Washington Public Power Supply System

Subject: NUCLEAR PROJECT 2
NRC INSPECTION REPORT 50-397/83-38 NOTICE OF VIOLATION

RESPONSE TO INSPECTION REPORT 83-38
NOTICE OF VIOLATION

EVALUATION OF CONCRETE AND REINFORCING STEEL
FOR
WASHINGTON PUBLIC POWER SUPPLY SYSTEM UNIT 2

BEAM 2B5 (21'0" x 4'6")
SEE NOTES 1, 2 & 3
(CONCEPTUAL LAYOUT OF BEAM STEEL)

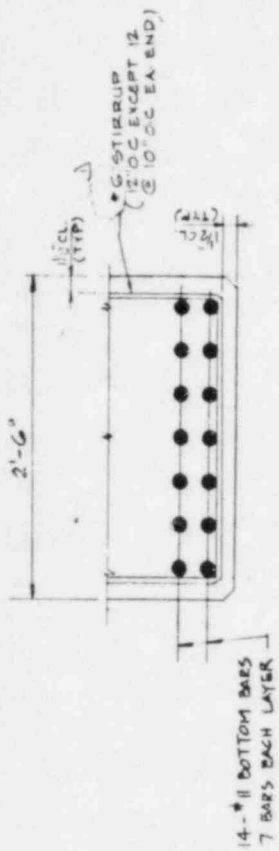
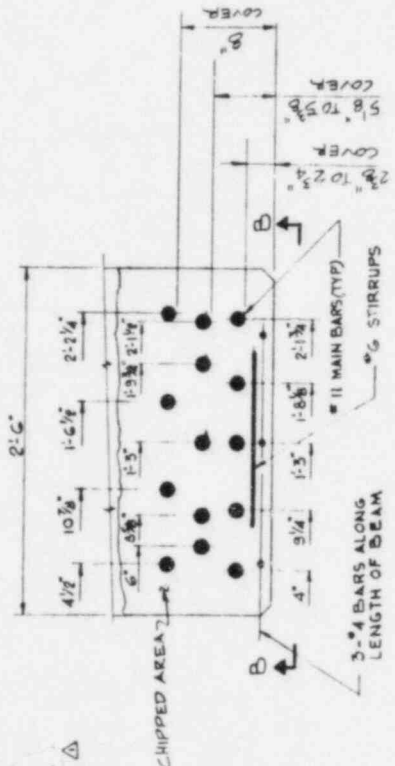
1) Further excavation after NRC CAT inspection found 5 bars in bottom-most layer, 5 in middle layer, and 4 in top layer as shown on SK-2. The deviation in bar and layer spacing would be acceptable provided the concrete was adequately consolidated. Beam 2B5 was found to have fully consolidated concrete tightly bonded to the rebars with no honeycomb. Placement of the rebar in 3 layers did not change the conservative effective depth used in the original calculations.				1) Beam 2B5 has been reanalyzed and checked and found to be structurally adequate.

SECTION A-A
SCALE 2" = 1'-0"

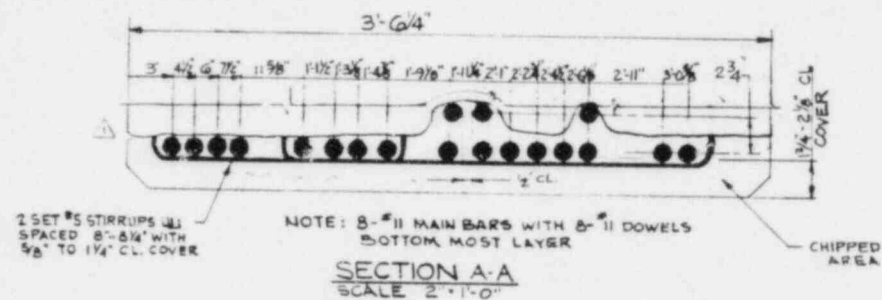
<u>SECTION B-B</u>	<u>SECTION B-B</u>				
Bottom Bars: 24-#11 in 3 layers	Bottom Bars: 9-#11	6'-6" West of column line 8.3	8-#11	None required	
Top Bars: 12-#11 in 2 layers	Top Bars: 9-#11				
RESOLUTION OF DISCREPANCIES:				COMMENT:

2) See 1) above.				2) Dimensions and bar sizes shown on as-built sketch SK-4 have been verified.	
3) Honeycomb has been removed. Effect of honeycomb and void on structural adequacy has been evaluated.

4) The patch has been removed completely and will be replaced.					
5) Derating tags will be reattached permanently to pertinent inserts upon completion of patching.

PILASTER/Col. 34 & M

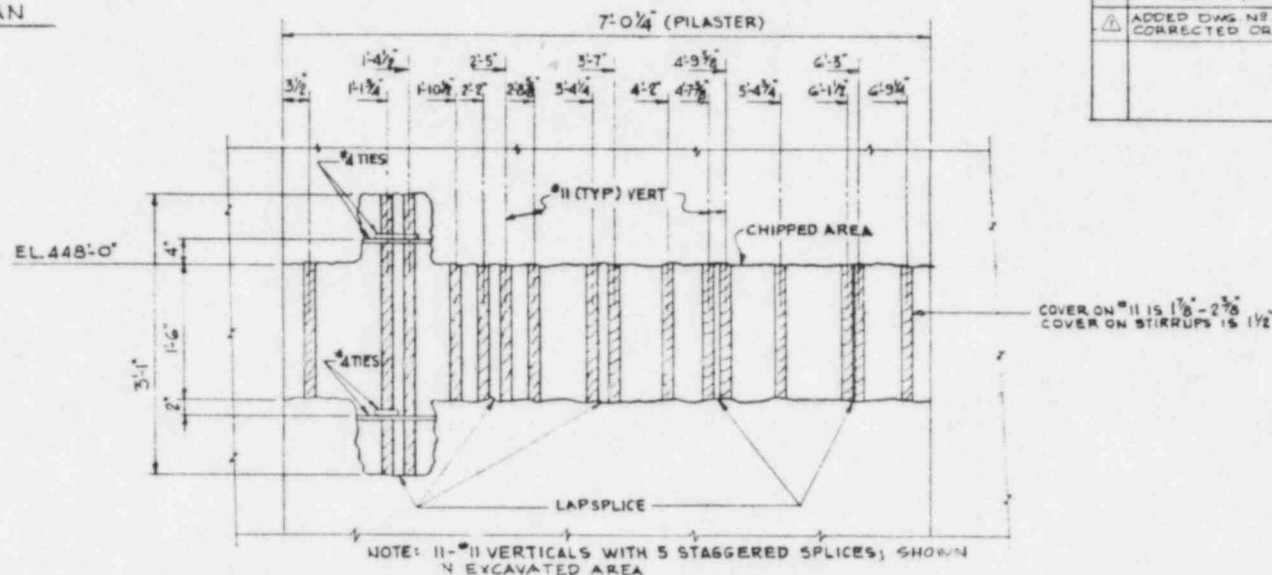
REINFORCEMENT REQUIRED BY ORIGINAL DESIGN AND SHOWN ON DESIGN DRAWINGS	REINFORCEMENT REQUIRED BY ANALYSIS FOR MOST CRITICAL OPERATING/SSE LOAD CONDITION	AS-BUILT CONDITIONS (SEE SKETCH NOTED)			DISCREPANCIES
		LOCATION OF EXCAVATION	BARS EXPOSED	DOWELS EXPOSED	
<u>VIEW A-A</u> Column Bars: 11-#11 in each 7'-0" face Ties: #4 at 24' O.C.	Same as original design	Column M-3.4 at elev. 448'-0"	<u>VIEW A-A</u> 11-#11 with alternate staggered lap splice	N/A	<u>ALL EXCAVATIONS</u> None
RESOLUTION OF DISCREPANCIES:				COMMENT:	
N/A				1) Excavation demonstrated that the concrete is fully consolidated and tightly bonded to the rebar. 2) The dimensions and bar sizes shown on as-built sketch SK-9 have been reverified.

PART PLAN OF WEST WALL (SOUTH END)
(SEE NOTE #2.)
A CONCEPTUAL LAYOUT OF WALL STEEL.

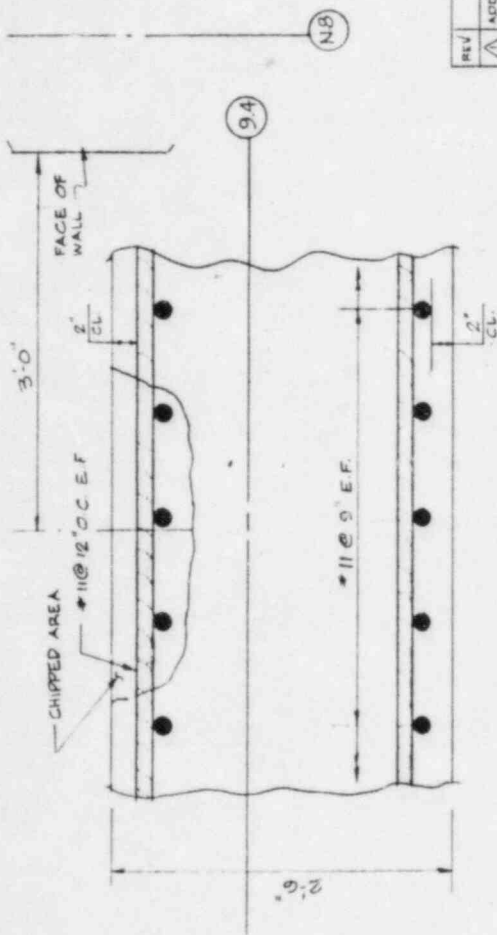
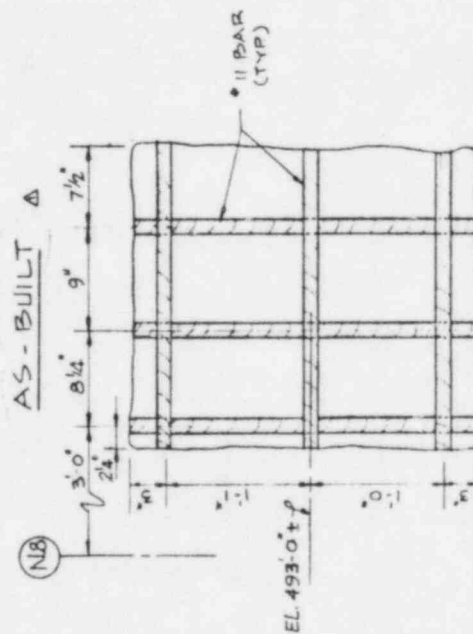
REINFORCEMENT REQUIRED BY ORIGINAL DESIGN AND SHOWN ON DESIGN DRAWINGS	REINFORCEMENT REQUIRED BY ANALYSIS FOR MOST CRITICAL OPERATING/SSE LOAD CONDITION	AS-BUILT CONDITIONS (SEE SKETCH NOTED)			DISCREPANCIES
		LOCATION OF EXCAVATION	BARS EXPOSED	DOWELS EXPOSED	
<u>ELEVATION VIEW A-A</u>			<u>ELEV VIEW A-A</u>		<u>ALL EXCAVATIONS</u>
(Interior face) Vertical Bars: #11 at 9" O.C. each face Horizontal Bars: #11 at 12" O.C. each face	Same as original design	Interior face of wall on column line 9.4, 4'-0" North of column line N.8	(Interior face) Ver- tical Bars: #11 at 9" O.C. Horizontal Bars: #11 at 12" and 13" O.C.	N/A	None
RESOLUTION OF DISCREPANCIES:				COMMENT:	
N/A				1) West exterior wall has been reanalyzed and checked and found to be structurally adequate. 2) Exposed concrete is adequately consolidated with some evidence of very minor air pockets. The concrete is tightly bonded to the rebar. 3) Dimensions and bar sizes shown on as-built sketch SK-10 have been verified.

STRUCTURAL COMPONENT FUEL POOL WALL ELEV. 588'-2 1/2", CONC/REINF BY CONTRACT 206A (SEE SKETCH NO. SK-12) SHEET 1 OF 2

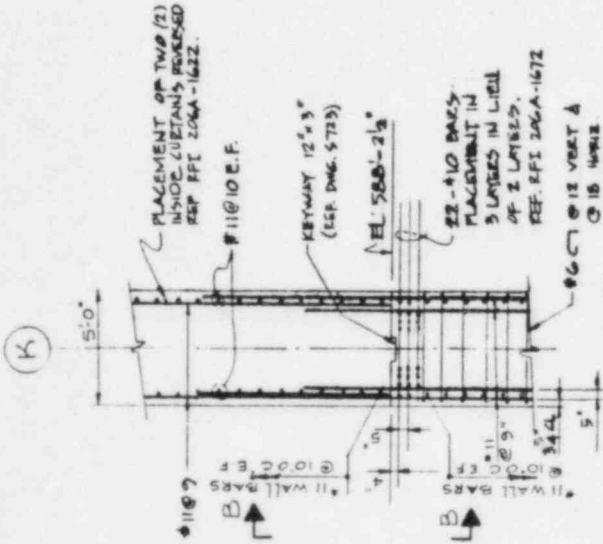
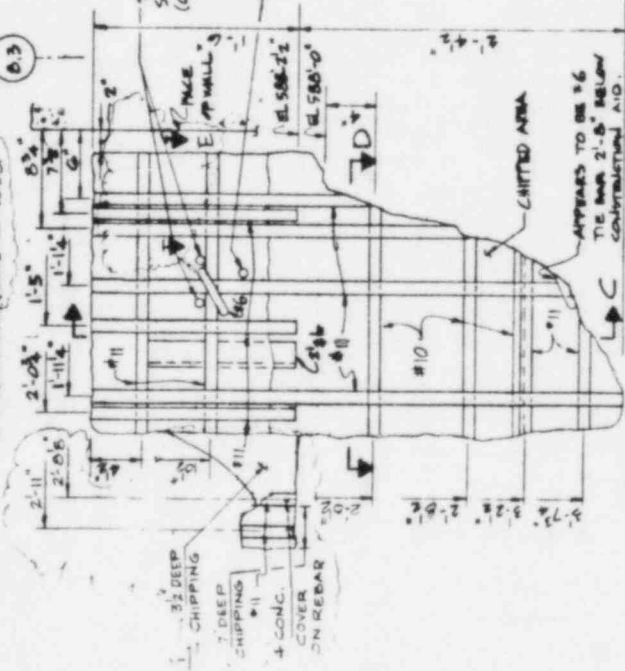
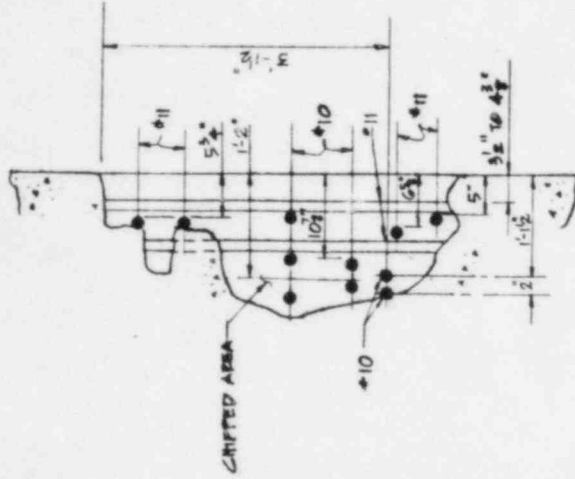
RESOLUTION OF DISCREPANCIES:				COMMENT:	
1) RFI 206A-1672 permitted contractor to revise placement of the 22-#10 bars from 2 layers to 3 layers (of 8, 8 and 6 bars) in order to provide access through the middle of the wall for tremie and vibrator use. The depth of the excavation for the #10 bars is approximately one-fourth the width of the wall (60 inches). Ex- trapolation of this quantity would provide reasonable assurance that 22-#10 bars were placed.				1) The fuel pool wall has been reanalyzed and checked and is structurally adequate.

2) The spacing deviation would be acceptable provided that concrete was adequately consolidated around the bars. Excavation demon- strated that the exposed concrete is fully consolidated and is tightly bonded to the rebar.				2) Subsequent to the NRC Representative's visit, placement procedures were discussed with the Foreman of reinforcing during concrete placement. He indicated that the bars were relocated to provide access for a tremie in order to properly place the concrete in the wall below the bars.

REINFORCEMENT REQUIRED BY ORIGINAL DESIGN AND SHOWN ON DESIGN DRAWINGS	REINFORCEMENT REQUIRED BY ANALYSIS FOR MOST CRITICAL OPERATING/SSE LOAD CONDITION	AS-BUILT CONDITIONS (SEE SKETCH NOTED)			DISCREPANCIES
		LOCATION OF EXCAVATION	BARS EXPOSED	DOWELS EXPOSED	
RESOLUTION OF DISCREPANCIES:				COMMENT:	
3) Excavation subsequent to the NRC CAT Representative visit exposed the third layer of #10 bars as shown on as-built sketch SK-12.				3) Excavation demonstrated that the exposed concrete is adequately consolidated and is tightly bonded to the rebars.	
				4) Dimensions and bar sizes shown on as-built sketch SK-12 have been verified.

PART PLAN @ EL. 422'-3"

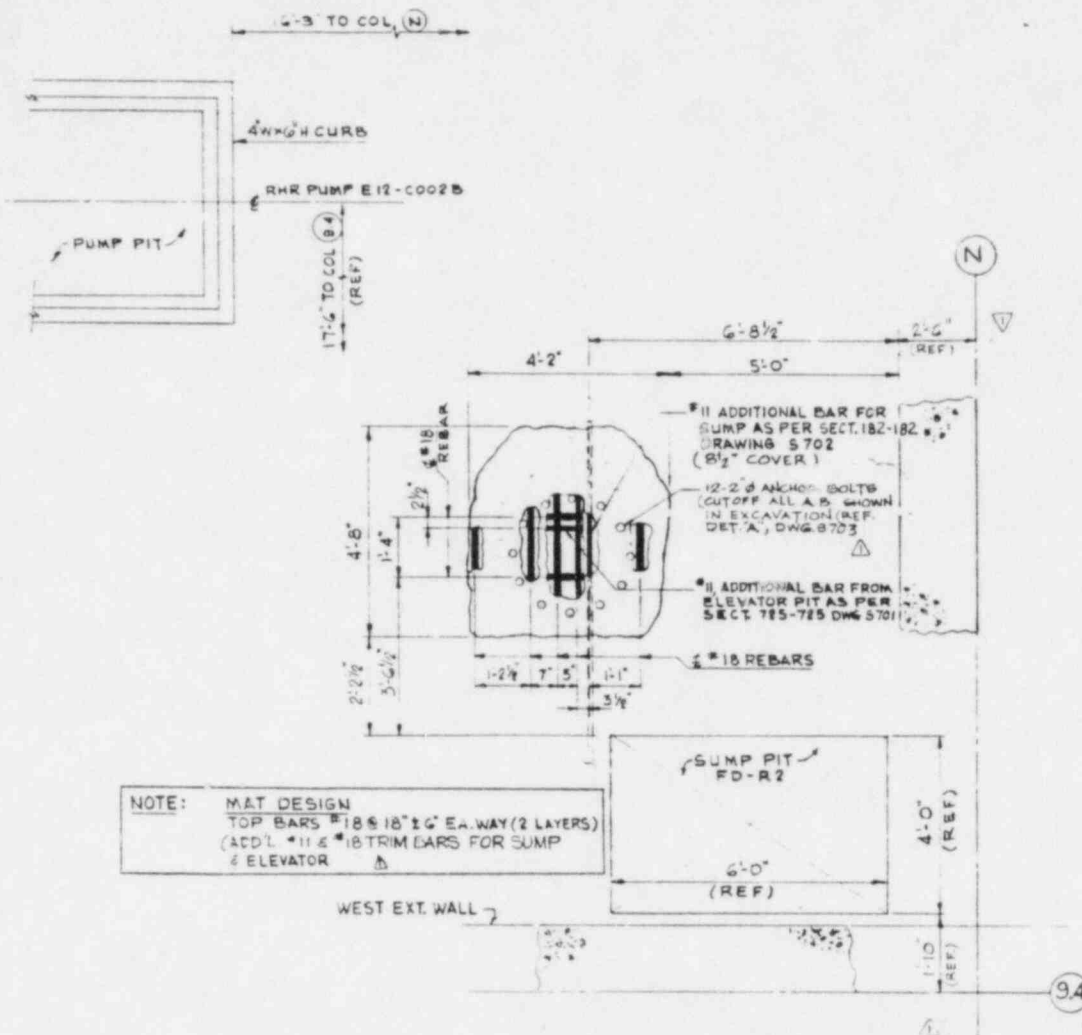
REINFORCEMENT REQUIRED BY ORIGINAL DESIGN AND SHOWN ON DESIGN DRAWINGS	REINFORCEMENT REQUIRED BY ANALYSIS FOR MOST CRITICAL OPERATING/SSE LOAD CONDITION	AS-BUILT CONDITIONS (SEE SKETCH NOTED)			DISCREPANCIES
		LOCATION OF EXCAVATION	BOTTOM BARS EXPOSED	DOWELS EXPOSED	
PART PLAN AT ELEV. 422'-3" Top bars: #18 at 18" +/- 6" O.C. each way Additional #11 and #18 bars around openings and at faces of sump and elevator pit.	Same as original design	5'-0" North of north face of wall on column line N and 8'-0 1/2" East of column line 9.4	Top bars: E-W: #18 at 14 1/2", 7", 5" and 16 1/2" O.C. N-S: #18 at 16" O.C. Additional #11 E-W bar from North face of sump and #11 N-S bar from elevator pit.	N/A	<u>ALL EXCAVATIONS</u> 1) Spacing deviation between E-W bars partly due to need to avoid inter- ference with 12-2 inch diameter anchor bolts in a 30 inch diameter bolt circle. 2) NRC Construction Appraisal Team identified one #11 sump face re- bar as not located in accordance with concrete shop drawing.

RESOLUTION OF DISCREPANCIES:				COMMENT:	
1) The spacing deviation would be acceptable provided that concrete was adequately consolidated around the bars. Excavation demon- strated that the exposed concrete is fully consolidated and is tightly bonded to the rebar. 2) Both the design drawing and the shop drawing called for a vertical configuration of #11 sump face bars but neither dimensioned their location. The location of the top #11 is acceptable for design, therefore, the discrepancy is resolved.				1) The dimensions and bar sizes shown on as-built sketch SK-13 have been verified.

PLAN @ EL 471'-0"

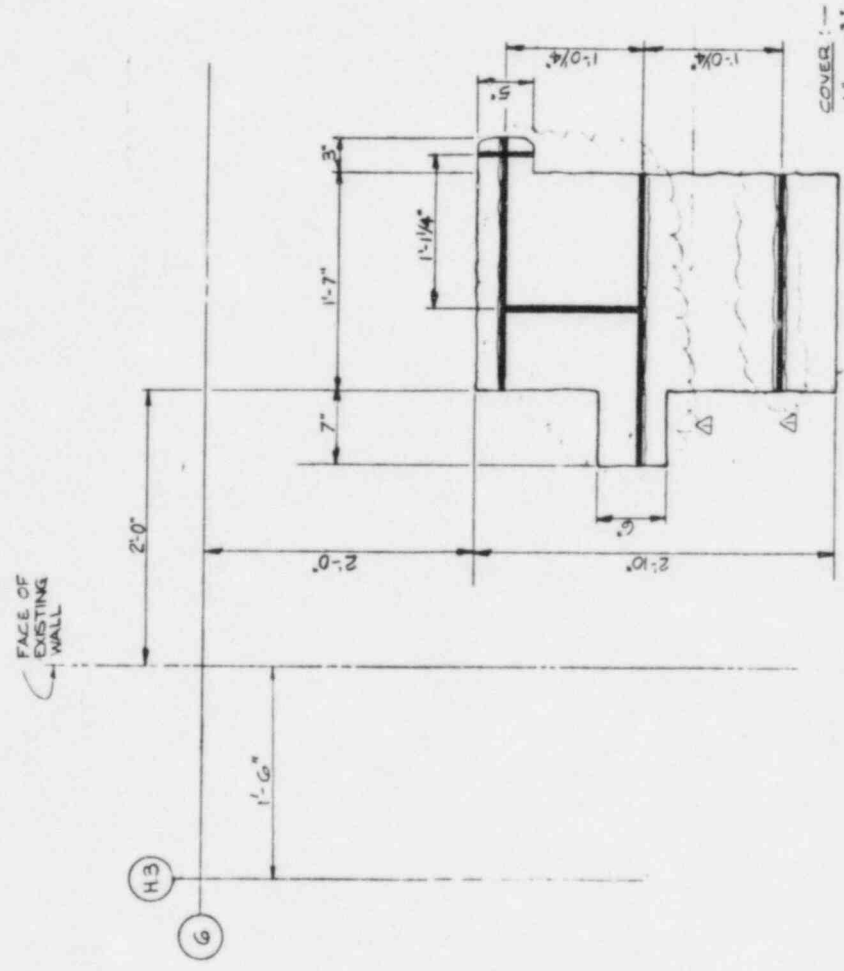
REINFORCEMENT REQUIRED BY ORIGINAL DESIGN AND SHOWN ON DESIGN DRAWINGS	REINFORCEMENT REQUIRED BY ANALYSIS FOR MOST CRITICAL OPERATING/SSE LOAD CONDITION	AS-BUILT CONDITIONS (SEE SKETCH NOTED)			DISCREPANCIES
		LOCATION OF EXCAVATION	BARS EXPOSED	DOWELS EXPOSED	
PLAN AT ELEV 471'-0" Top BARS: #6 at 12" O.C. each way	Same as original design	3'-6" South of column line H.3 and 2'-0" West of column line 6	Bottom bars: Not exposed Top bars: E-W: #6 at 1'-1 1/4" N-S: #6 at 1'-0 1/4" and 1'- 0 1/4"	N/A	None <u>ALL EXCAVATIONS</u>
RESOLUTION OF DISCREPANCIES:				COMMENT:	
N/A				1) Excavation demonstrated that exposed concrete is fully consolidated and is tightly bonded to the rebar. 2) Dimensions and bar sizes shown on as-built sketch SK-16 have been verified.

STRUCTURAL COMPONENT EAST EXTERIOR WALL ELEV 476'-0", CONC/REINF BY CONTRACT 6426 (SEE SKETCH NO. SK-17) SHEET 1 OF 1

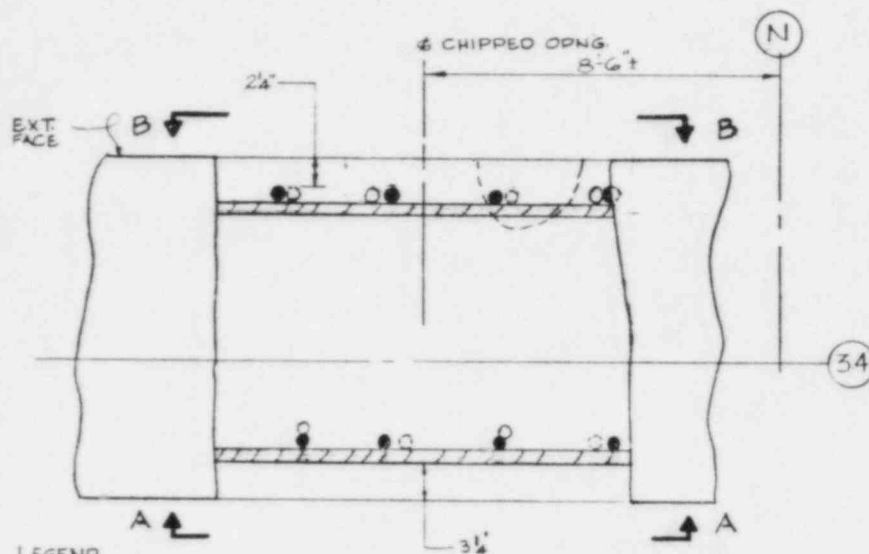
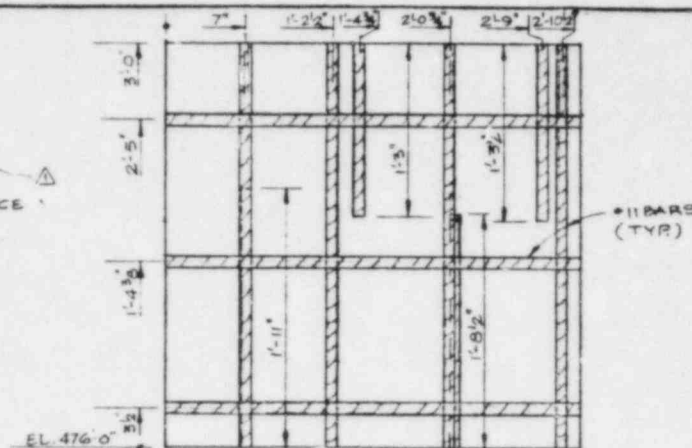
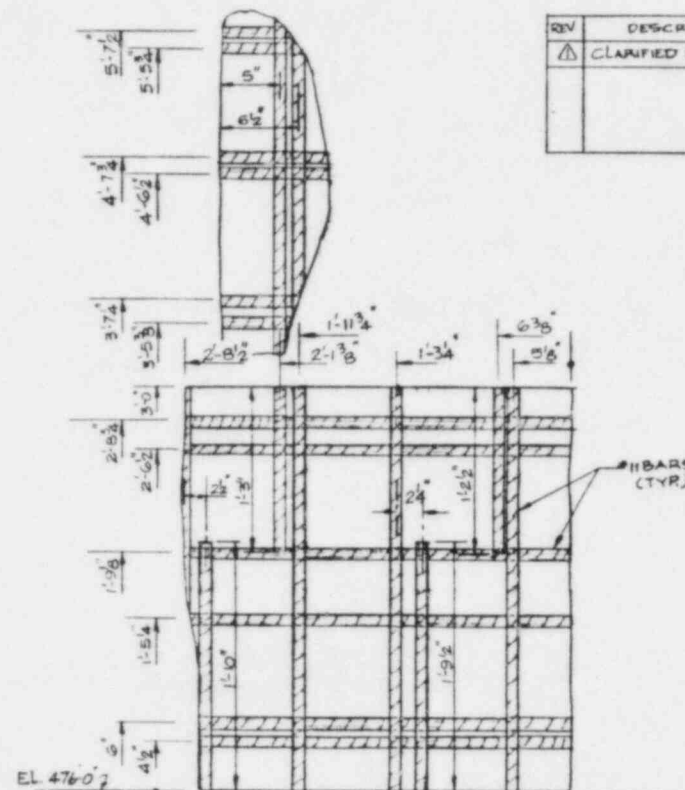
RESOLUTION OF DISCREPANCIES:				COMMENT:	
1) Vendor Drawing BS-RB-33 shows staggered laps of #11 bars spaced at 11" O.C. to #11 bars spaced at 12" O.C. As shown on sketch SK-17A (detailed layout of bars), the spacing of bars is such that some bars will not be contact or non-contact spliced. Request for Information 6426-329 was submitted by the contractor requesting technical direction to resolve the problem. In response, the engineer directed the contractor to add 2XB3 splices at such locations. The additional bars are shown on sketch SK-17B, and are the additional horizontal bars found in the excavation. These additional bars satisfy the original design intent.				1) Excavation demonstrated that the exposed concrete is fully consolidated and tightly bonded to the rebar.
